WP 134-74-01

Bay of Quinte Crossing
at Belleville

FEASIBILITY
FOUNDATION INVESTIGATION REPORT

Bay of Quinte Crossing at Belleville
Hwy. 14, District 8, Kingston
W.P. 134-74-01, Site 28-28

CASE A: Toe of Fill Slopes Not Closer than 20 ft. from Shoreline

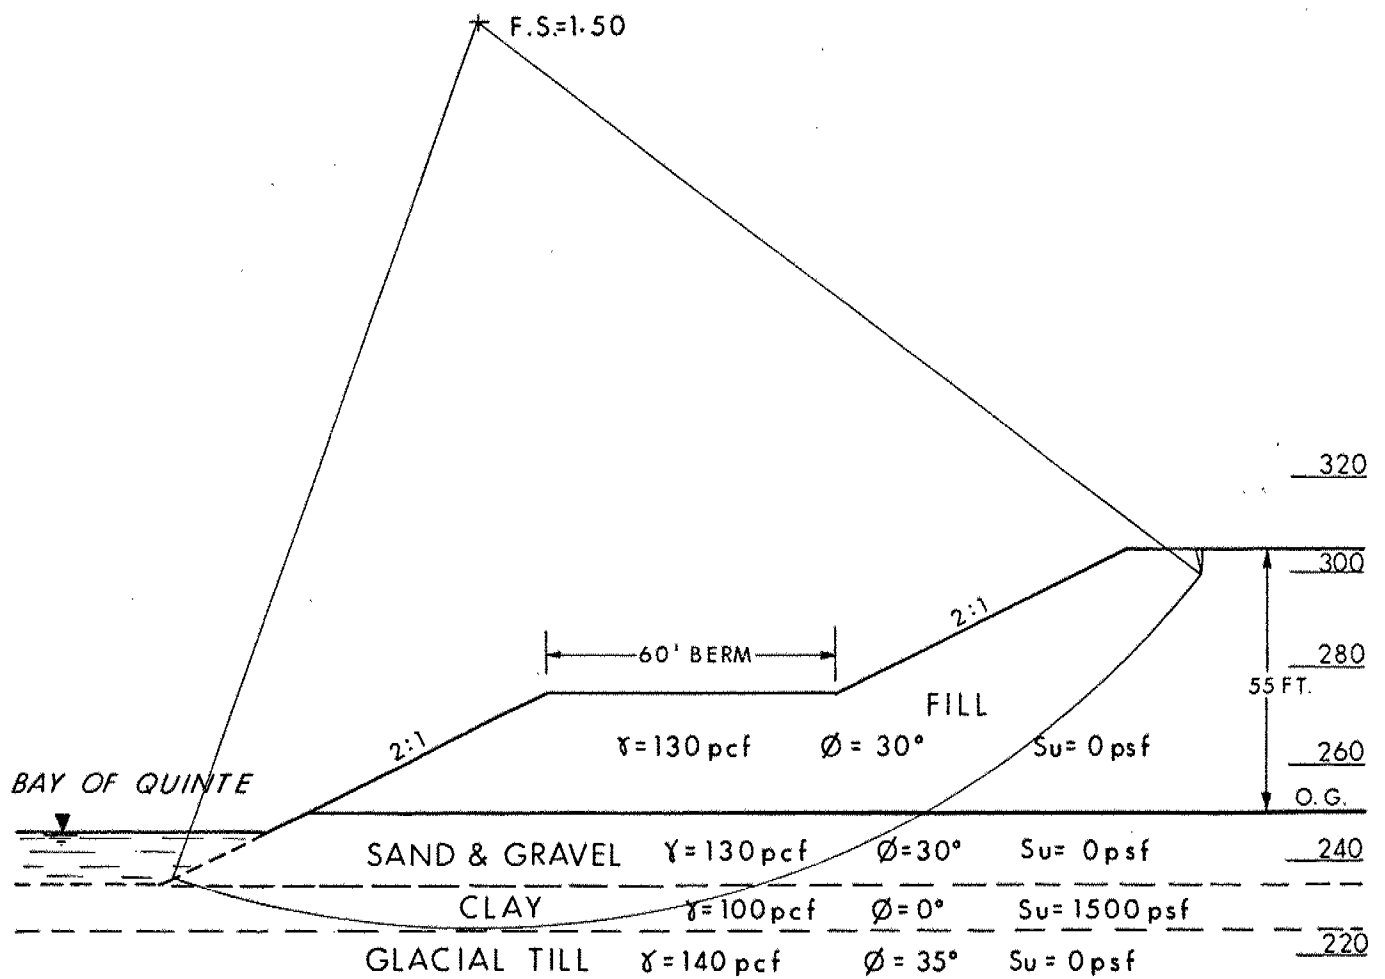
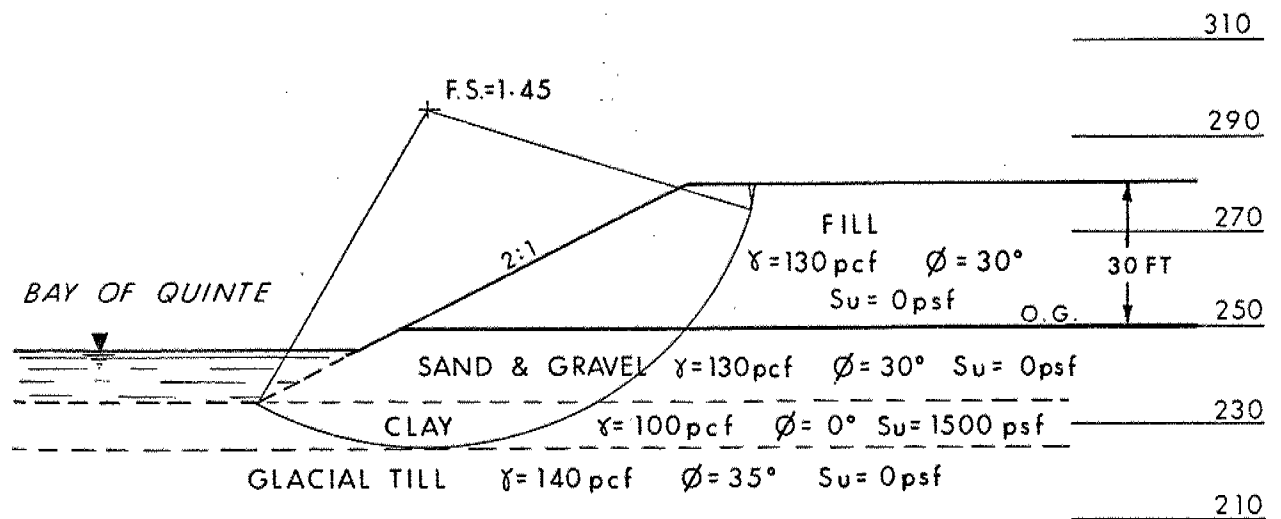
These recommendations are summarized in Figure 9, together with the critical slip circle and assumed subsoil conditions for 40 foot and 50 foot fill heights.

These recommendations are shown on Figure 10, together with the critical slip circles and the assumed subsoil stratigraphy.

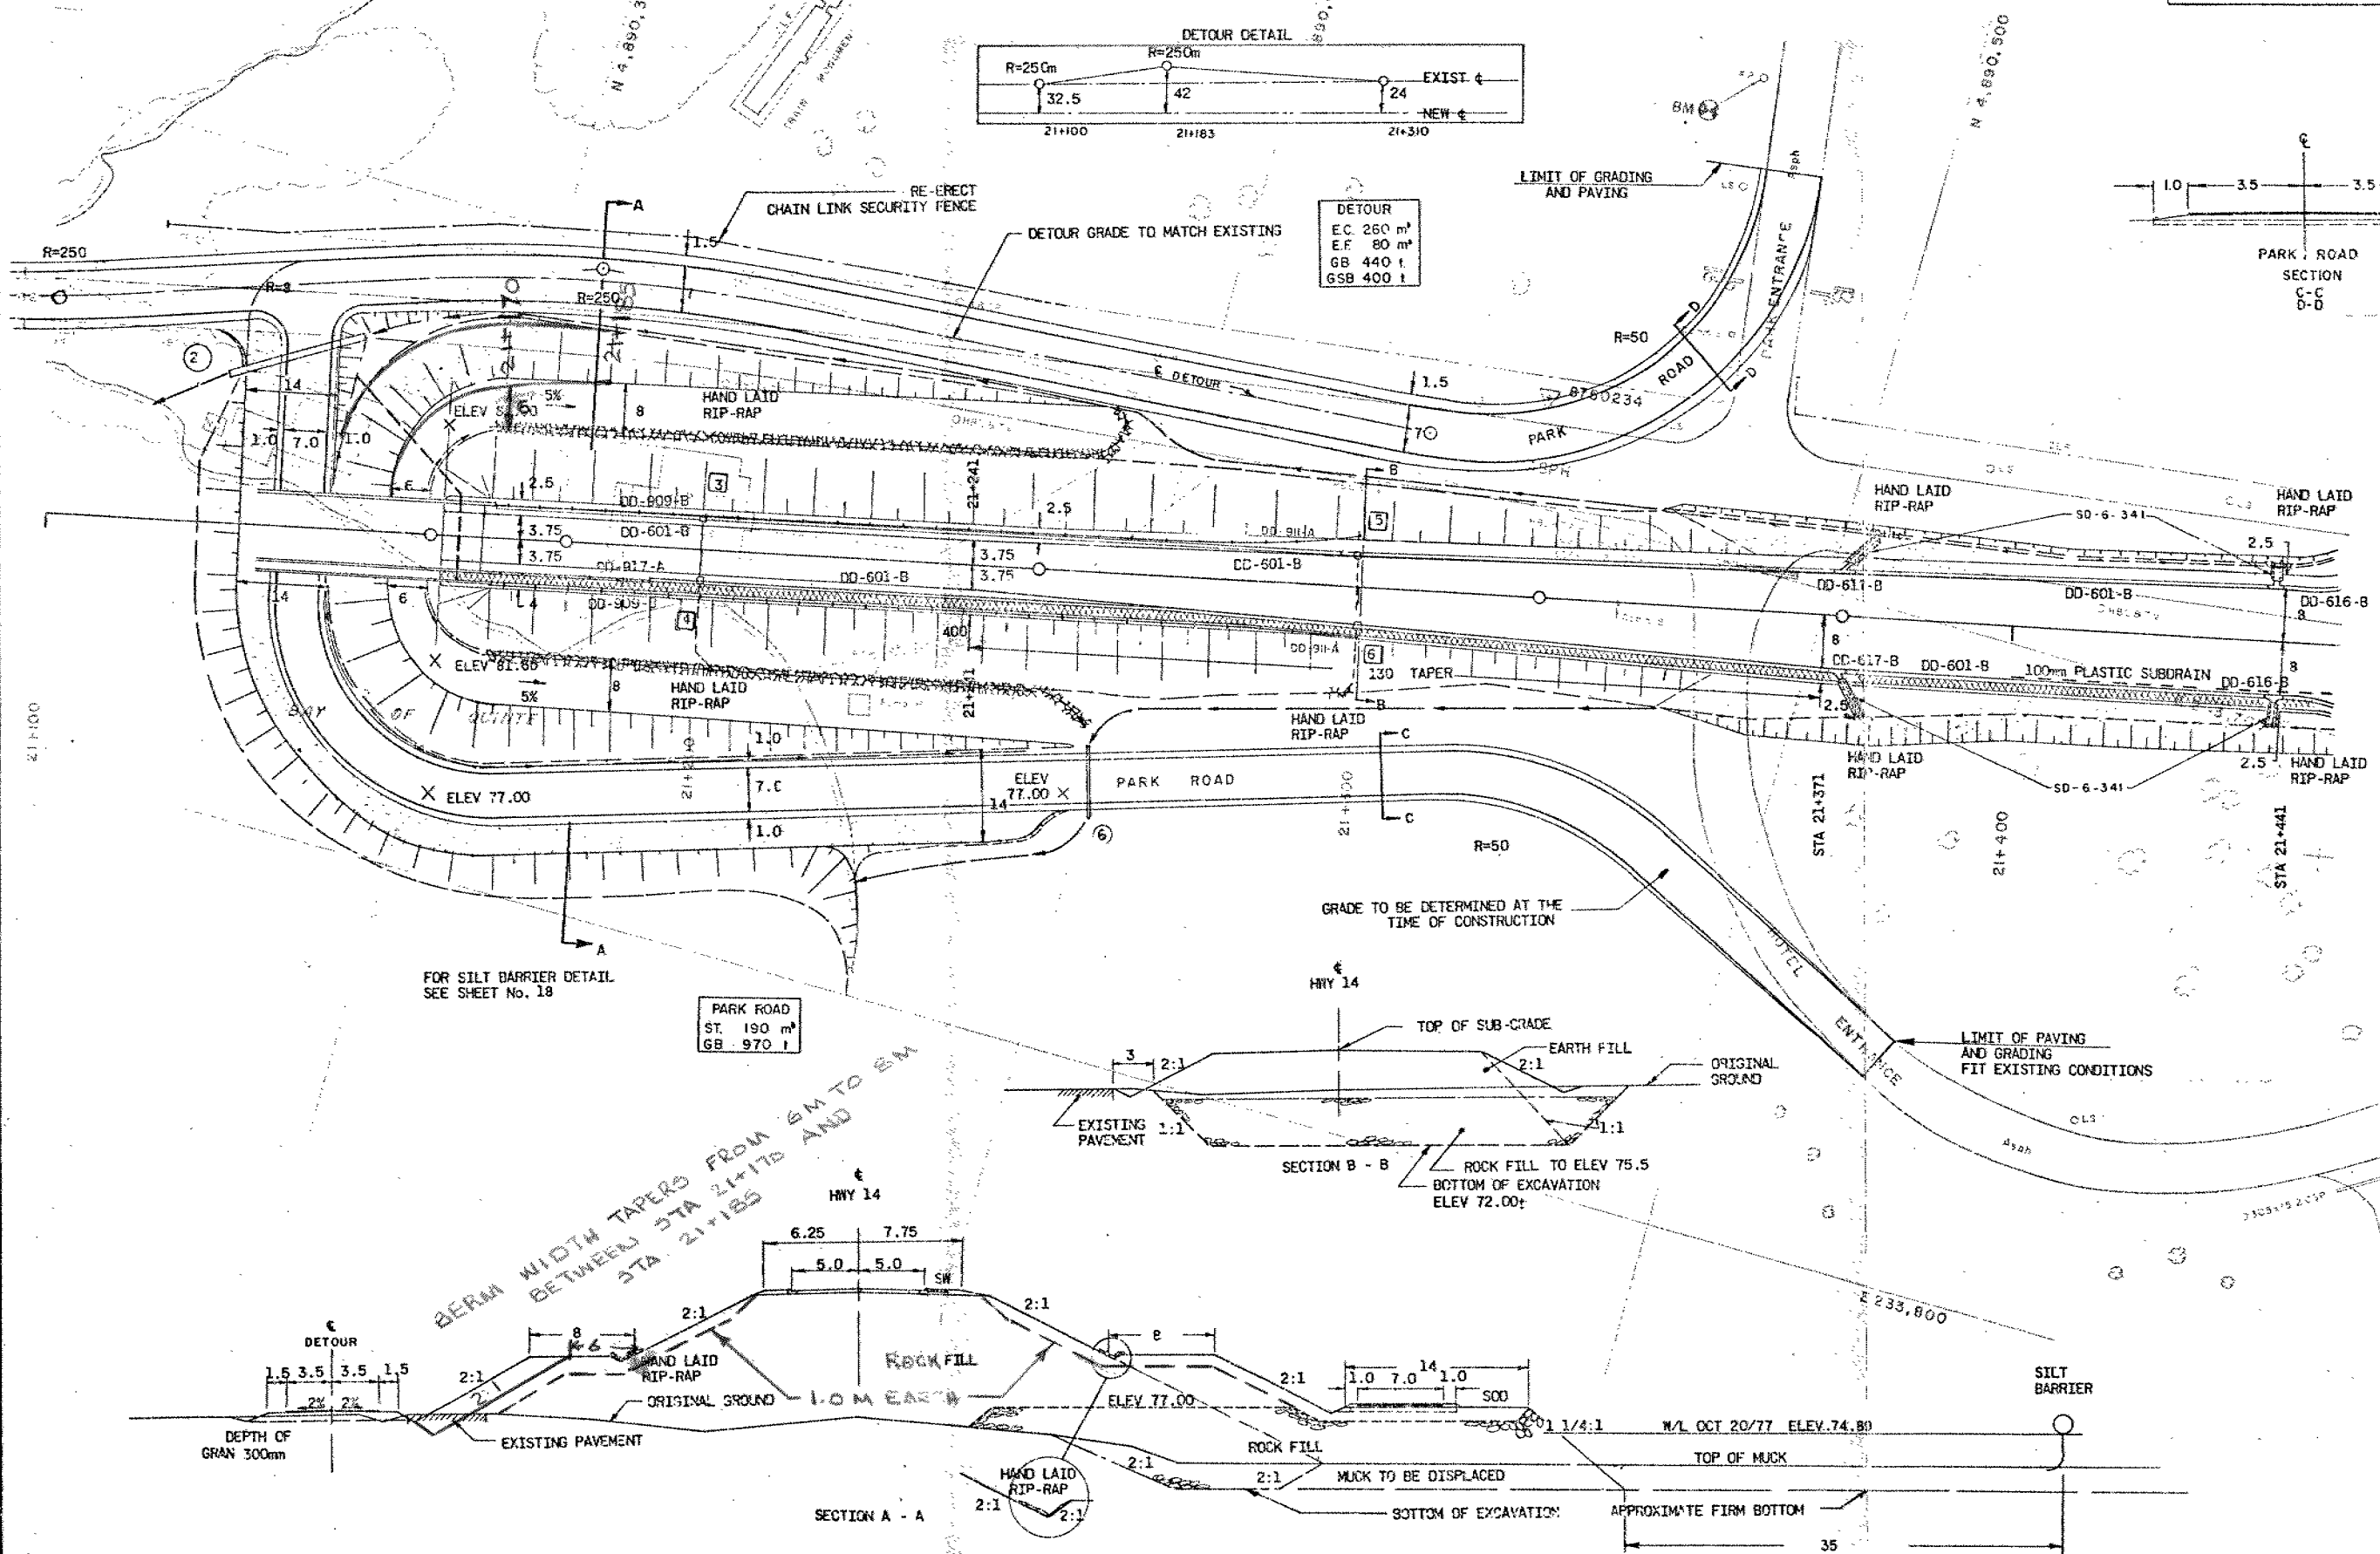
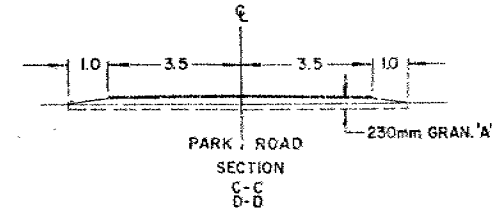
Further to your recent memo, we have reviewed the revised geometry incorporating a modified upper berm width ranging from 6 m to 8 m between Sta. 21+170 and Sta. 21+185 for the north approach. This memo confirms our telephone conversation with you indicating that the proposed modification will be satisfactory from the stability point of view.

Further to our telephone conversation on Thursday, November 13th, we enclose a sketch showing proposed modifications to the upper berm of the north approach. Considering the fact that there must be a sufficient depth of earth on the approach to support tree and shrub growth, the side slope should be constructed at a 2:1 slope rather than at the 1½:1 slope recommended by the Construction Office.
